AGENDA  
Village of Chenequa  
Monday, June 9, 2025  
31275 W County Road K, Chenequa, WI 53029

## STAFF REVIEW

**Subject:** Site Plan Review

**Project Description:** Proposed Accessory Structure

Landscape Plan  
John Klatt, PLA, ASLA  
Chris Miracle, PLA, ASLA  
Sheet Number: 1/2  
Date: 5.15.2025

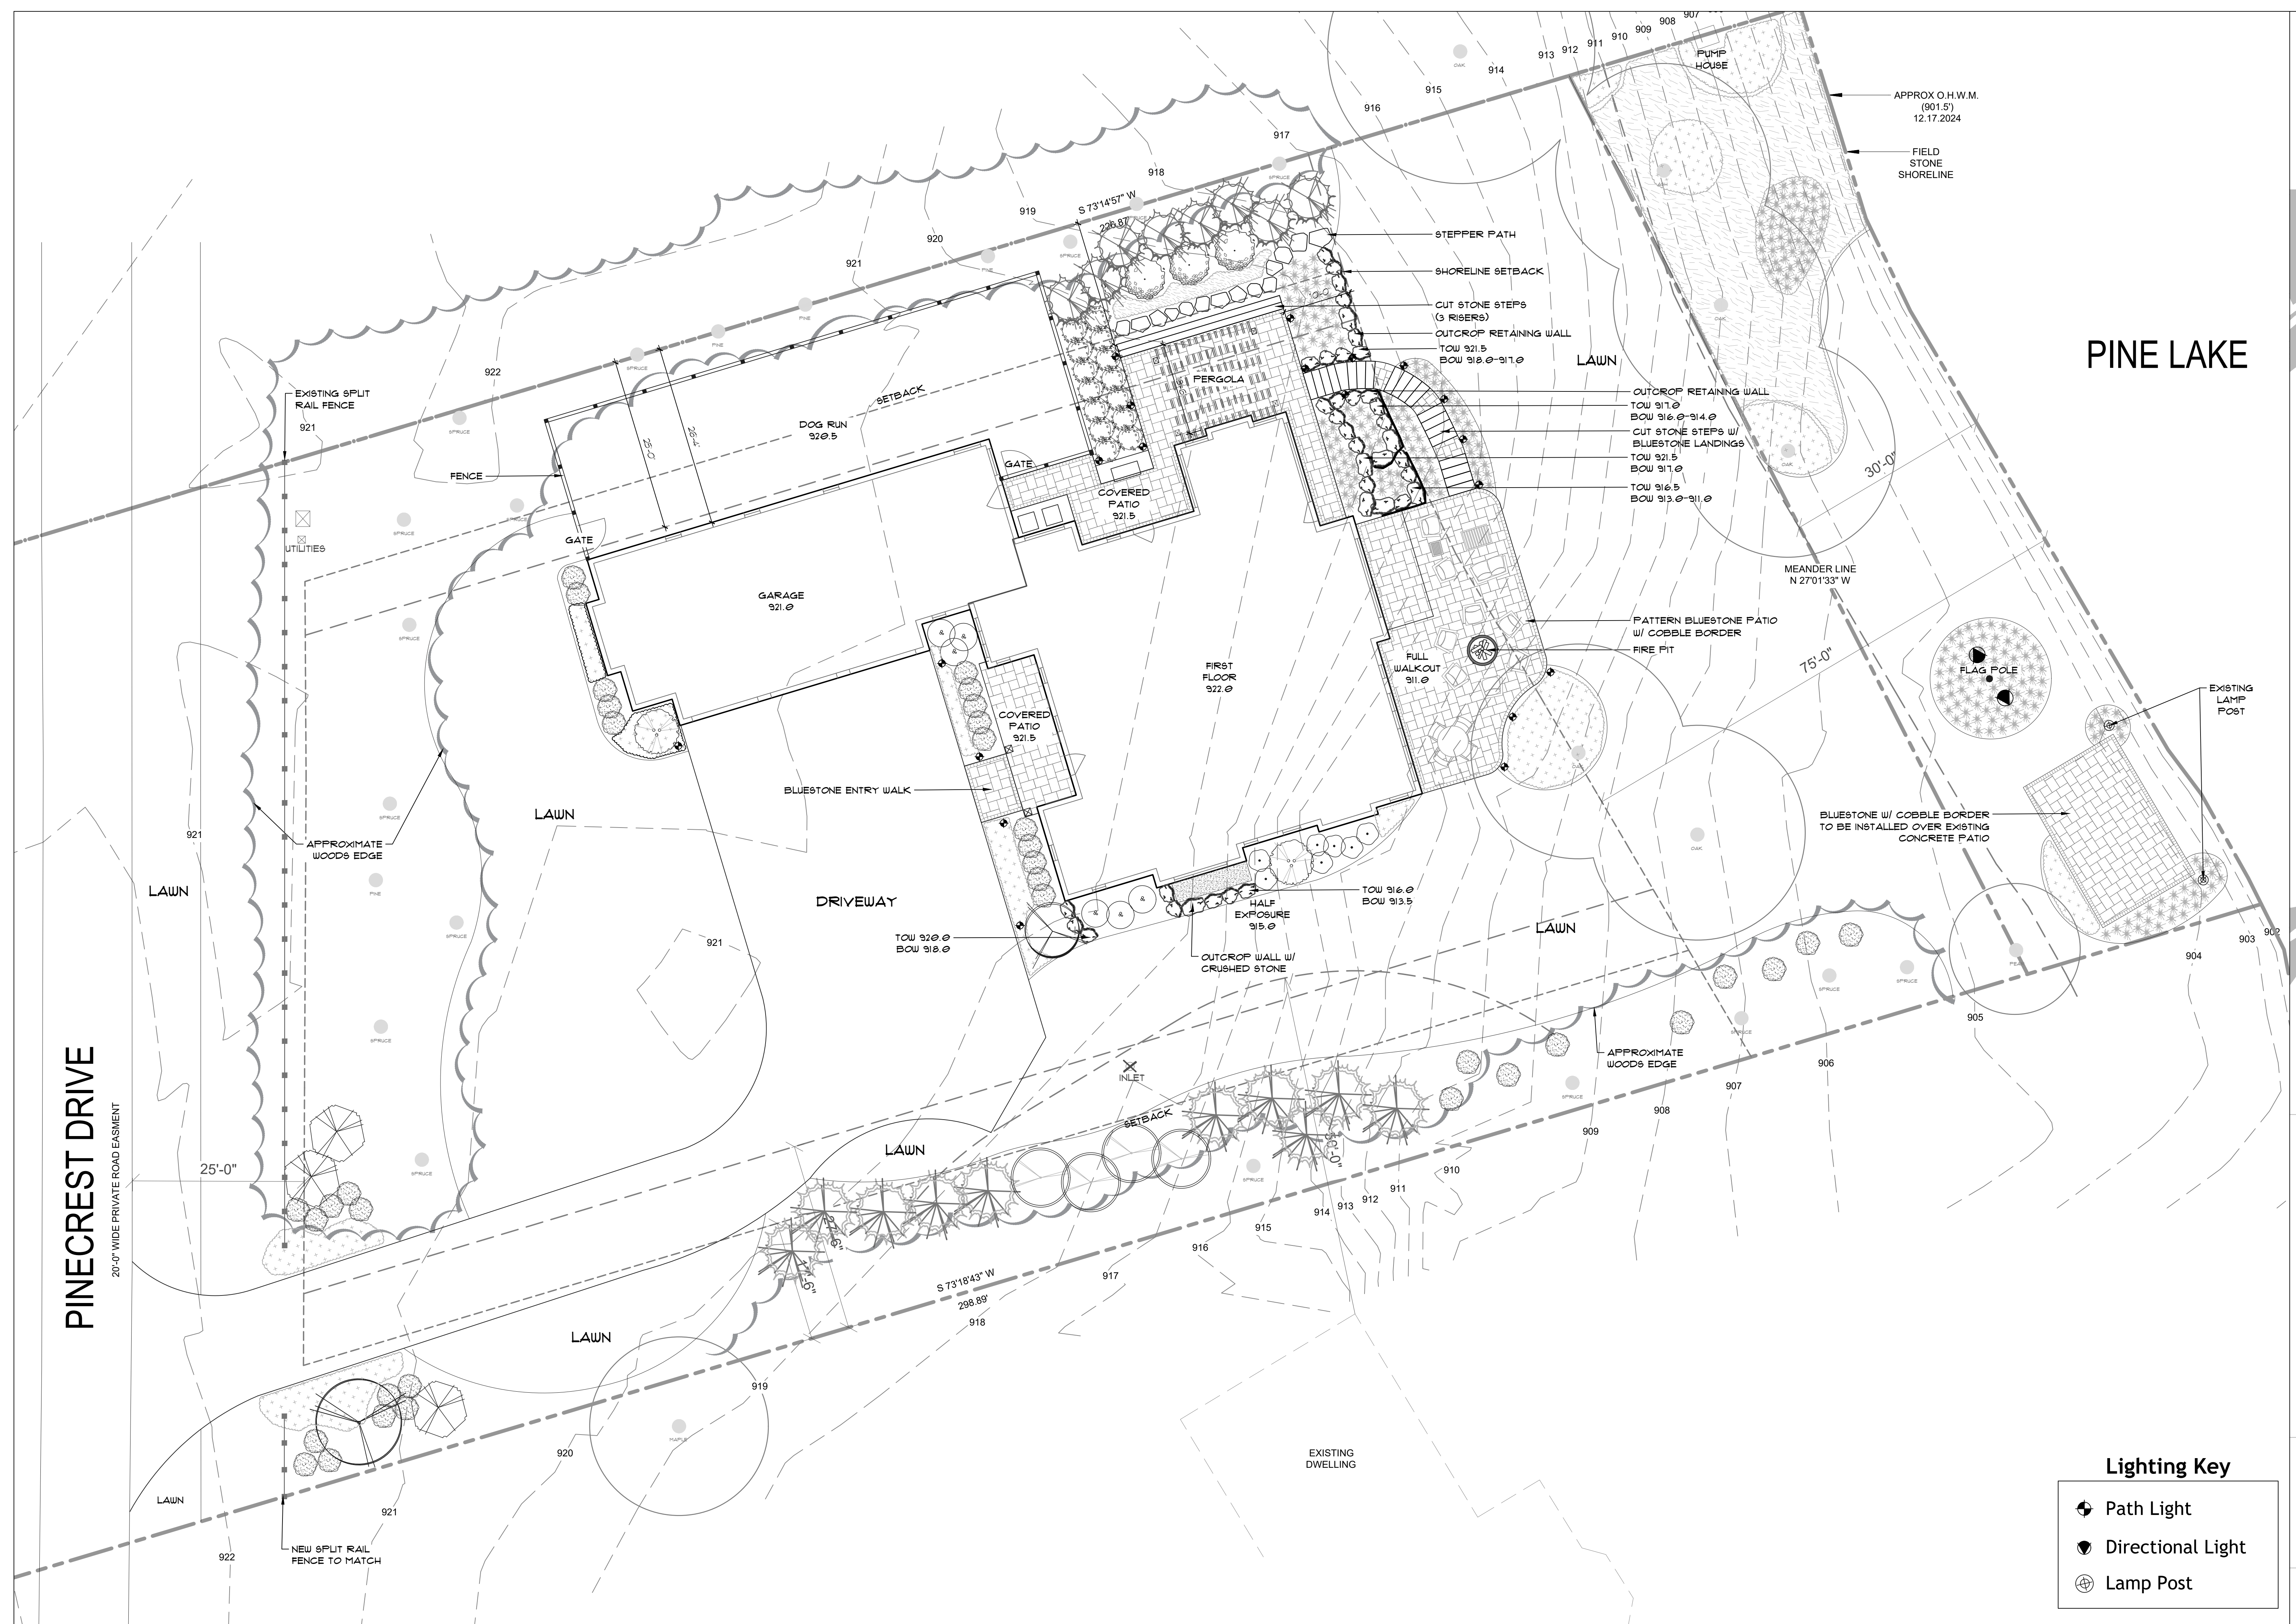
- b. These patios are proposed to be constructed of bluestone with a cobble border.
  - c. Location of these patios can be found on the provided landscape and lighting plan

- c. Stairs
    - i. The landscape plan proposes a single set of stairs that connect the patio on the north side of the dwelling with the patio on the lakeside of the dwelling.

- ii. The applicants seek permission to place a bluestone paver on top of the existing patio to match the other proposed patios,
    - iii. This modification would not result in an increase in patio footprint.

2. Proposed Landscape Lighting
    - a. The landscape plan also proposes 20 fully shielded pathway lights around the property.
      - i. A spec sheet for the proposed landscape light is provided in the packet
